Comments and Responses Volume 4

San Francisco Public Utilities Commission CALAVERAS DAM REPLACEMENT PROJECT

San Francisco Planning Department File No. 2005.0161E
State Clearinghouse No. 2005102102

DATE: January 5, 2011
TO: Members of the Planning Commission and Interested Parties
FROM: Bill Wycko, Environmental Review Officer
RE: Comments and Responses on Draft Environmental Impact Report for Case No. 2005.0161E, Calaveras Dam Replacement Project

FIGURE 11.1.1: CDRP TEMPORARY IMPACTS TO CALIFORNIA TIGER SALAMANDER HABITAT

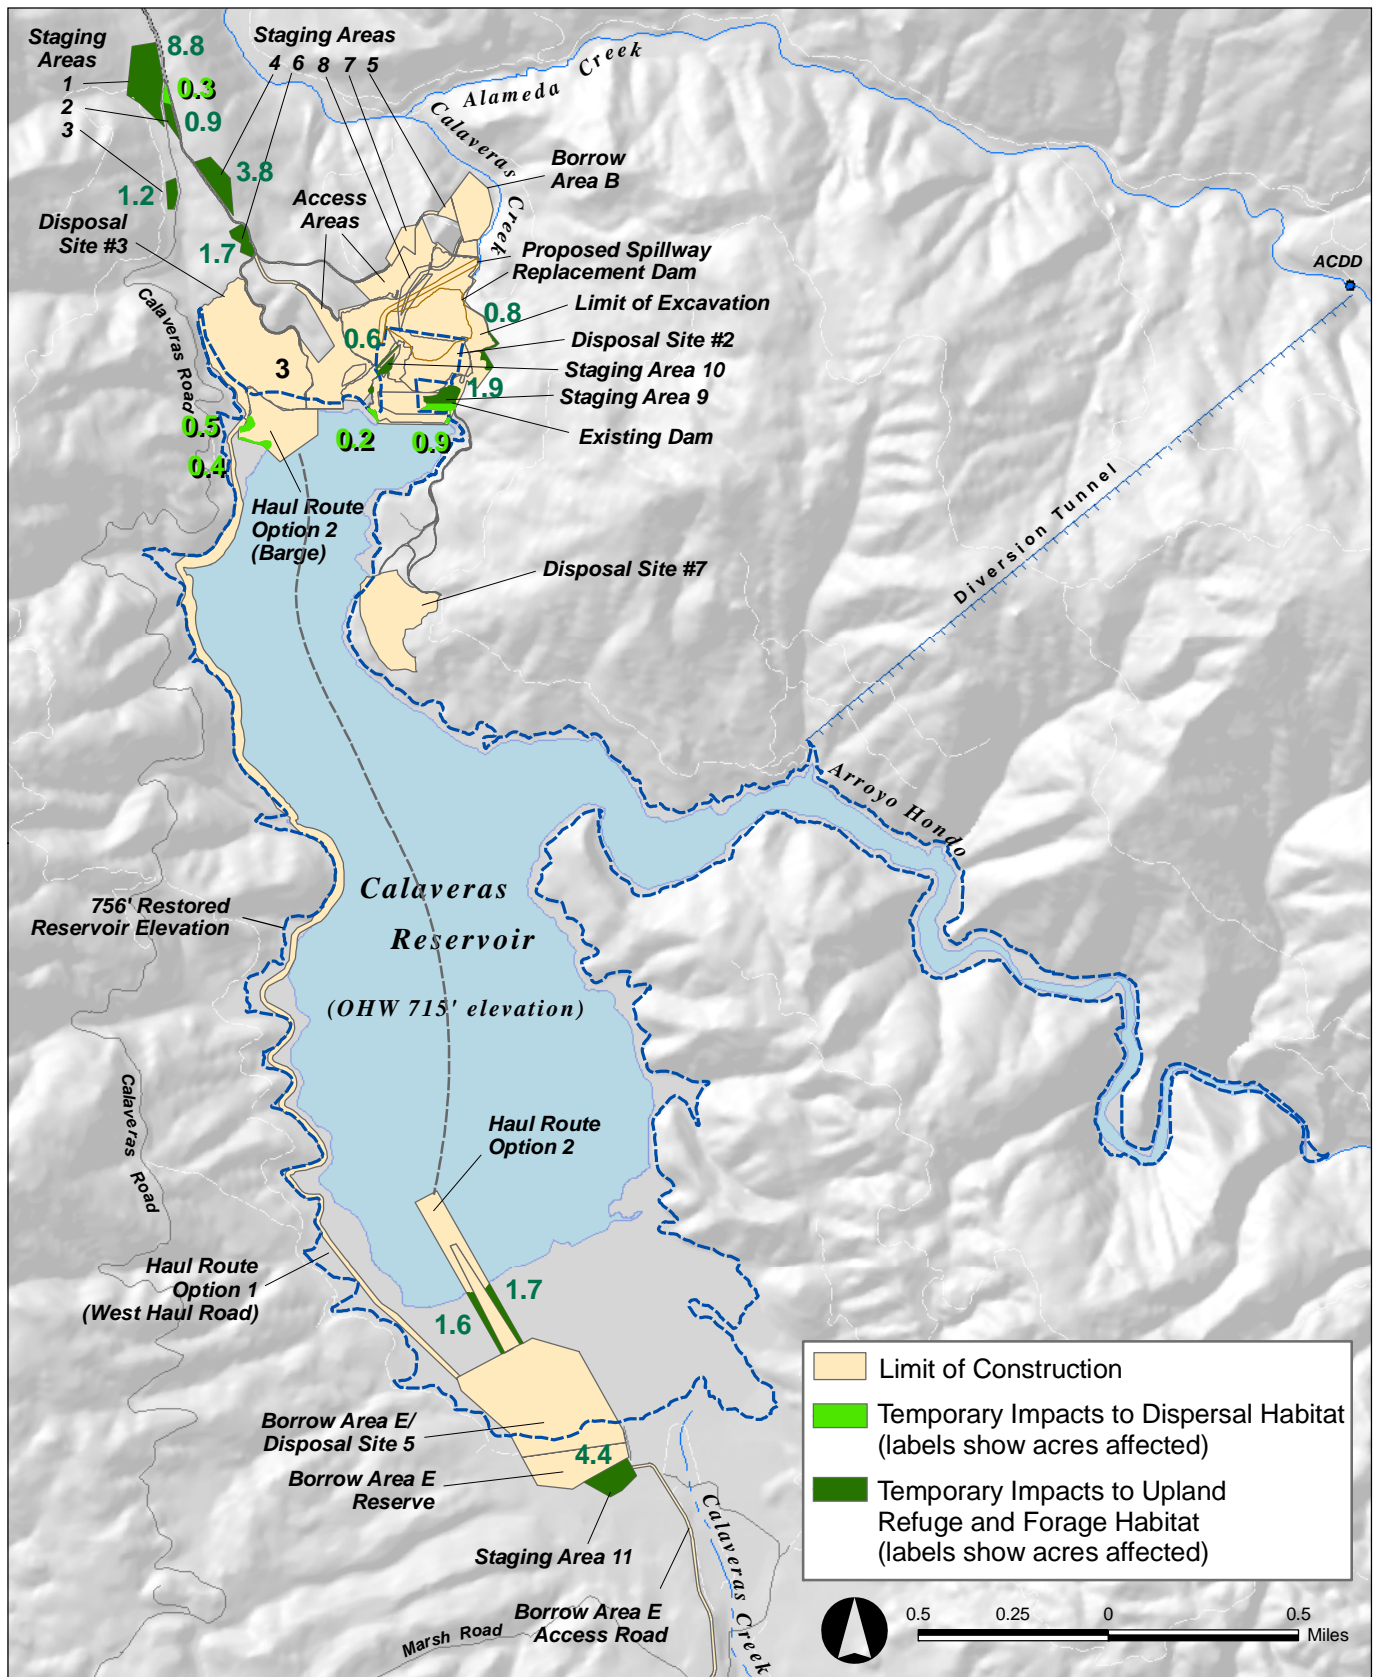
We are designating critical habitat that allows for dispersal between extant occurrences within 0.70 mi (1.1 km) of each other. This distance is consistent with the final listing rule (69 FR 47212; August 4, 2004) and the final critical habitat designation for the CTS in Santa Barbara County (69 FR 68568; November 24, 2004). Trenham (pers comm. 2004) predicted that a distance of 0.70 mi would capture 99 percent of all interpond movements between breeding adults.

Figure 11.1.1: CDRP Temporary Impacts to California Tiger Salamander Habitat, is provided to show the locations and sizes of temporary impacts to California tiger salamander habitat. The EIR defines temporary impacts as including activities that would affect a species or its habitat only during the construction period (Vol. 1, Chapter 4, Section 4.4.2.2, page 4.71). The EIR does not provide a detailed construction schedule by project component; therefore, it is assumed that all components could be used in any or all of the four construction years. In compliance with CEQA, the EIR includes compensatory mitigation that would fully mitigate impacts on California tiger salamander (Vol. 2, Chapter 5, Section 5.4, EIR page 5-11). However, it is acknowledged that CDFG can require additional measures for impacts on California tiger salamander in compliance with the California Endangered Species Act.

FIGURE 1: CALAVERAS DAM REPLACEMENT PROJECT AND MITIGATION AREAS LOCATOR MAP (UPDATED)

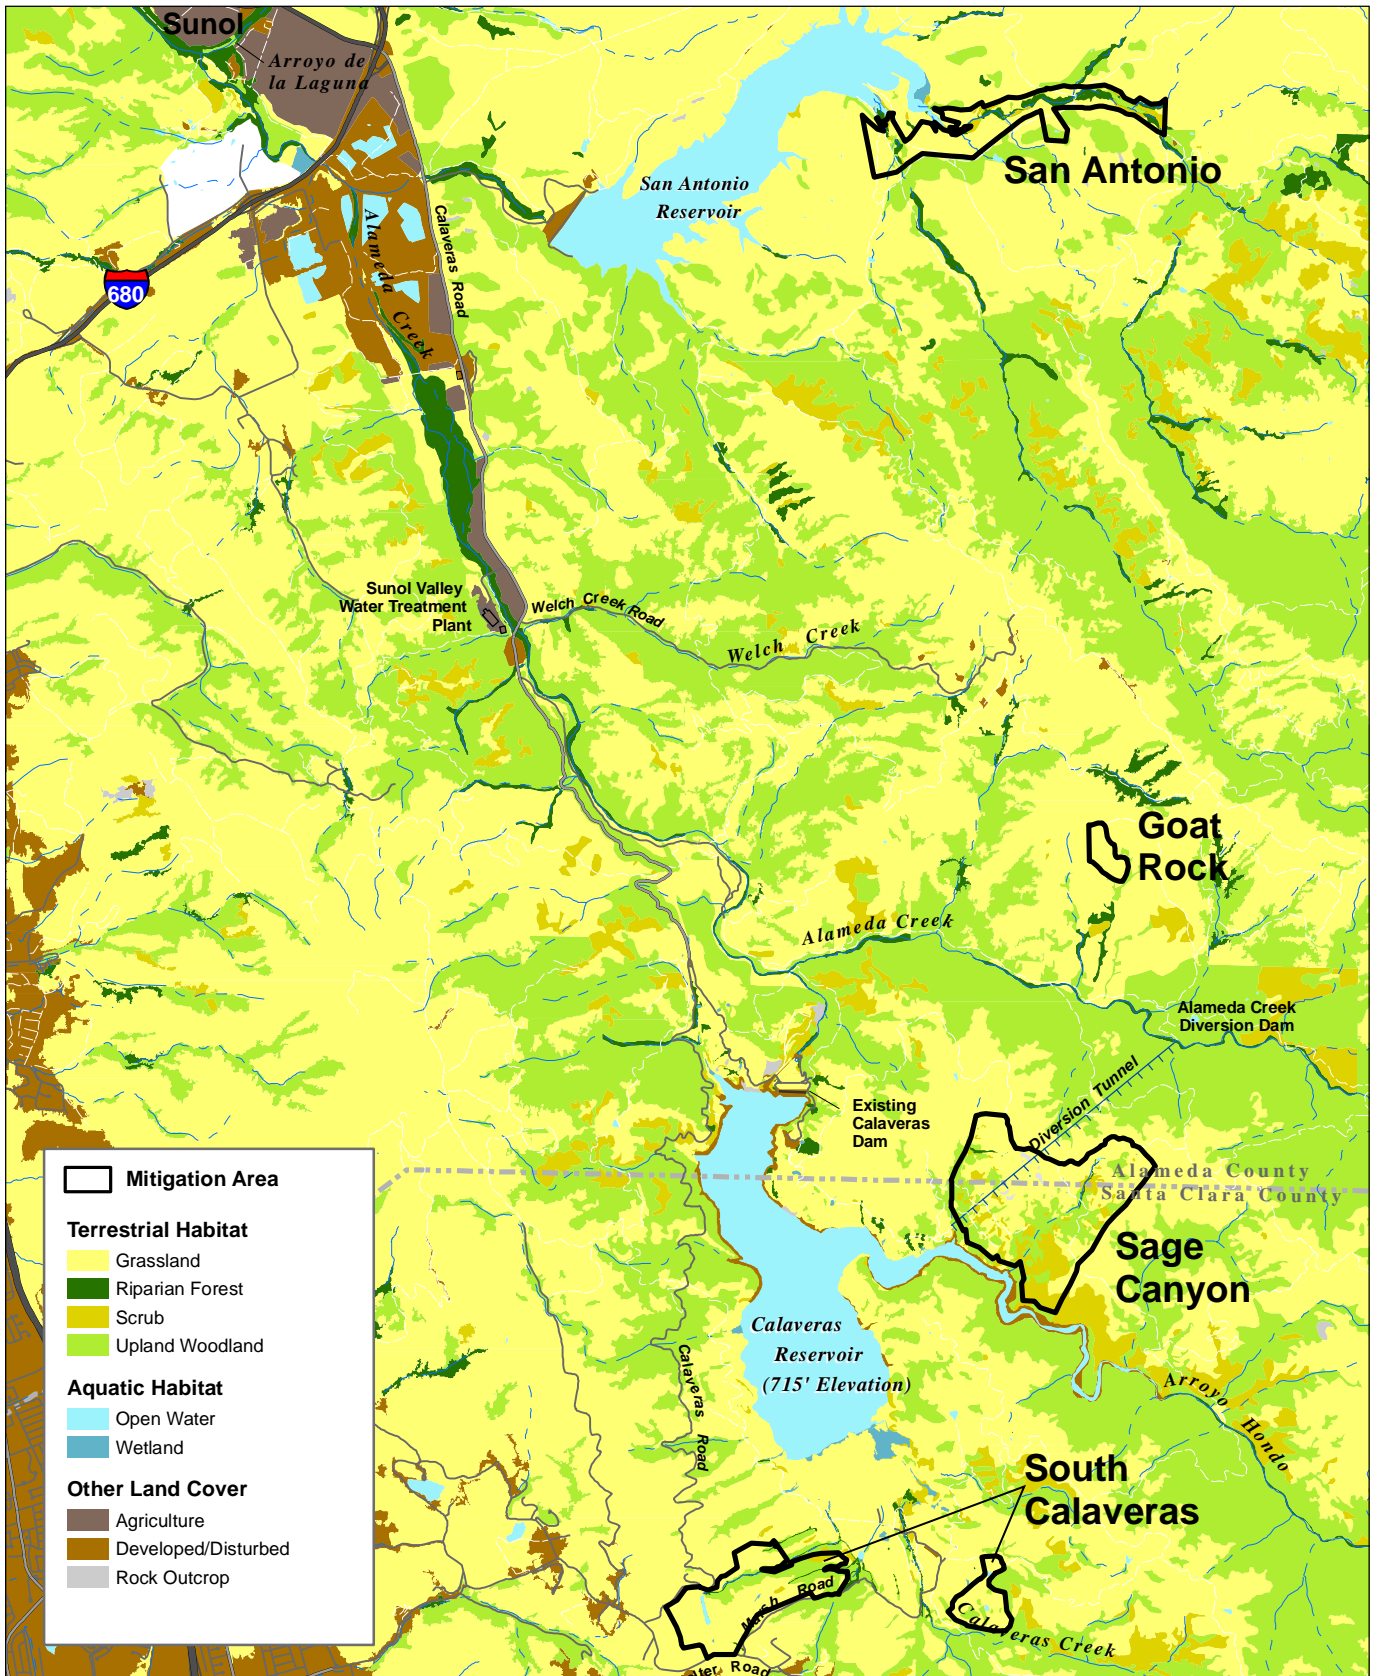
A-EBRPD-20 The comment notes that Appendix C.2 is missing figures and that the Goat Rock Mitigation Area described in the EIR is smaller than the Goat Rock Mitigation Area described on a figure obtained by EBRPD from the U.S. Army Corps of Engineers. The comment notes that portions of two recreational trails are within the mitigation area and requests that potential impacts resulting from restrictions on use of the area be identified.

The comment is correct that Appendix C.2 is missing figures. Figures 1 and 2, and the photo appendix are added to Appendix C.2; copies are provided as part of this response (these additions to the EIR are shown on the following pages). Two appendices related to mitigation have been added to the EIR: Appendix C.3 is an update to Appendix C.2, and Appendix C.4 provides a description of the Koopmann Road Mitigation Area.
